DEVELOPMENT APPLICATION ASSESSMENT REPORT

Application Number:	DA2022/0904
----------------------------	-------------

Responsible Officer:	Maxwell Duncan
Land to be developed (Address):	Lot 32 DP 7912, 23 Coles Road FRESHWATER NSW 2096
Proposed Development:	Demolition works and construction of a dwelling house including swimming pool
Zoning:	Warringah LEP2011 - Land zoned R2 Low Density Residential
Development Permissible:	Yes
Existing Use Rights:	No
Consent Authority:	Northern Beaches Council
Land and Environment Court Action:	No
Owner:	Jonathan James McVicker
Applicant:	Jonathan James McVicker

Image 1 - Building envelope non-compliance

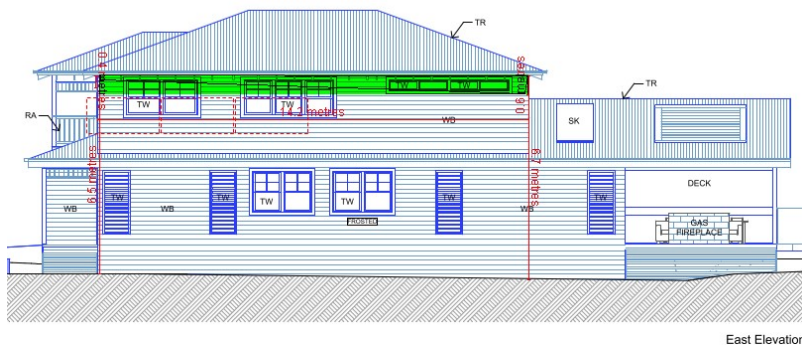
The proposal sits outside of the building envelope on the eastern facade as depicted in image 1. The southern eastern obtains an encroachment of 0.4m - 0.6m in vertical height for a horizontal length of 14.2metres, resulting in a maximum variation of 12%.

The proposal is compliant with the maximum height of buildings development standard, wall height control, and side boundary setbacks control. Therefore, the proposal does not become visually dominant by virtue of its height and bulk as the first floor addition includes articulation to mitigate any unreasonable bulk and scale.

The proposal is accompanied with shadow diagrams that demonstrates adequate solar access and light to the subject site and neighbouring sites. Privacy has been incorporated into the design through the inclusion of privacy screens along the northern and southern deck edges to mitigate any unreasonable privacy impacts.

The dwelling is considered to respond to the topography of the site by minimising unreasonable levels of excavation and stepping the design to ensure a sympathetic siting of the dwelling.
